APICAL INDUSTRIES, INC.
dba DART AEROSPACE

ENGINEERING CHANGE NOTICE NO.

05360

DWG TITLE: CUTTER SUB ASSY

SHEET 7, ZONE C3 IS:

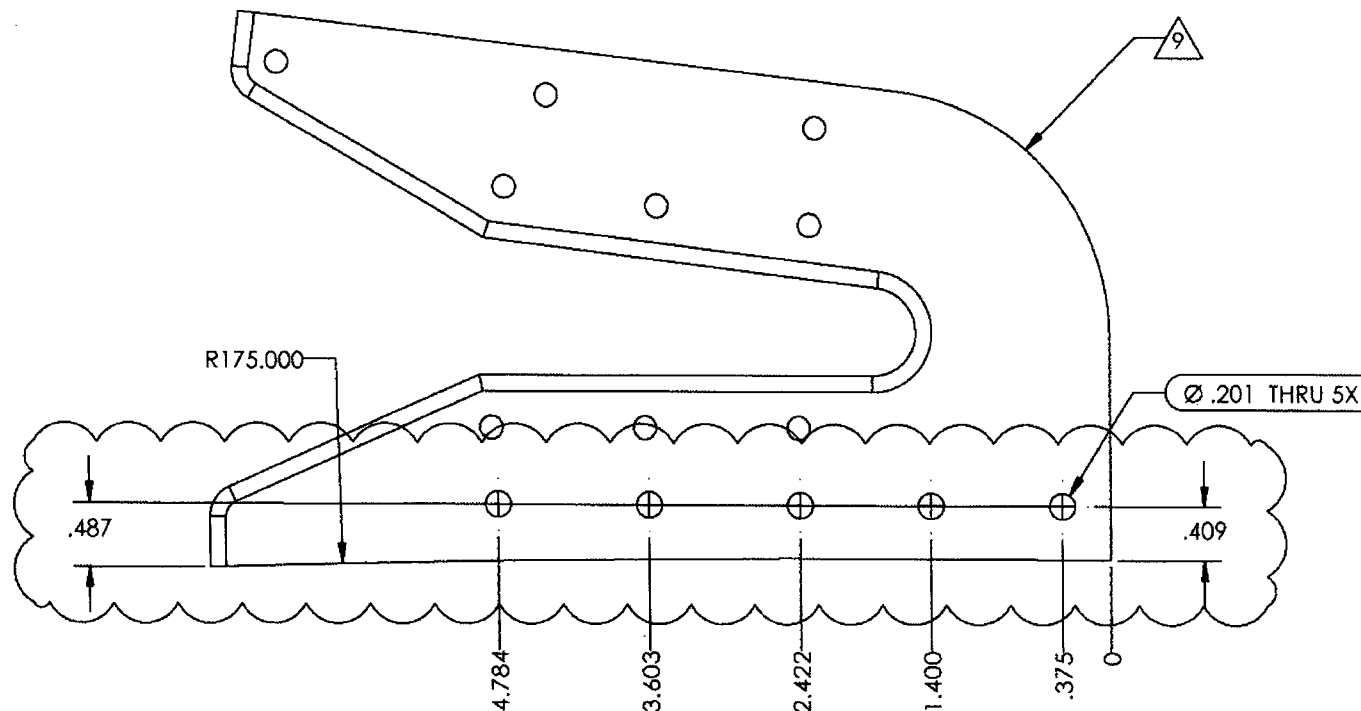
REASON: REVISED DIMENSIONS

SHEET 1, ZONE A6 IS:

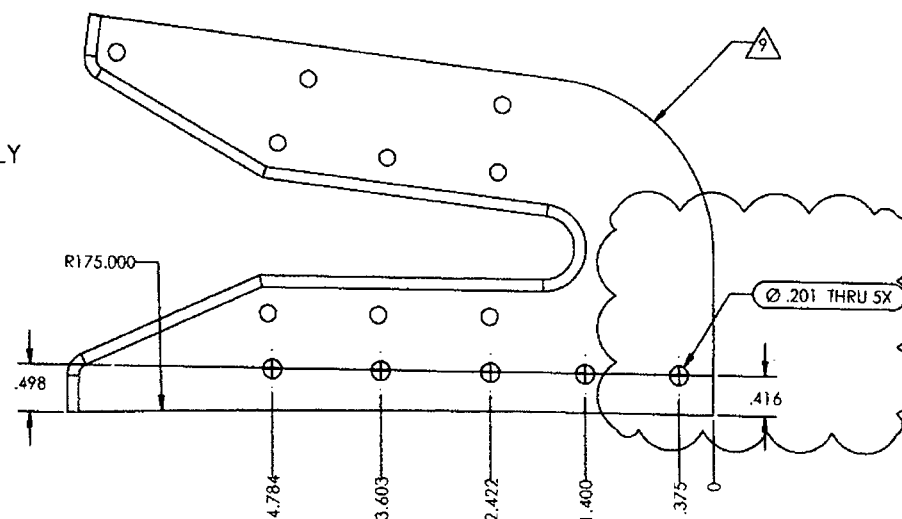
REASON: REVISED NOTES

IS

- 1 MATERIAL: ALUMINUM 7075-T651 PER AMS-QQ-A-250/12
- 2 FINISH IAW MPP-172 SECTION 2.1, 3.3 & 4.3.
- 3 MATERIAL: AISI A2 TOOL STEEL
CONDITION: ANNEALED
POST PROCESS: HEAT TREAT TO 58-62 Rc ROCKWELL HARDNESS
- 4 FINISH: PRIME IAW MPP-172 SECTION 3.3; 1-2 MIL MAX
5. DEBURR AND BREAK ALL SHARP EDGES EXCEPT WHERE OTHERWISE NOTED
6. IDENTIFY IAW MPP-120
- 7 APPLY F/N 5 AS REQUIRED TO ALL FAYING SURFACES OF F/N 2 UPON ASSEMBLY
- 8 CUTTING EDGE INTENDED TO BE SHARP, DO NOT BREAK SHARP EDGE
- 9 ALL DIMENSIONS NOT SPECIFIED ARE CONTROLLED BY 646.9710.

SHEET 7, ZONE C5 IS:
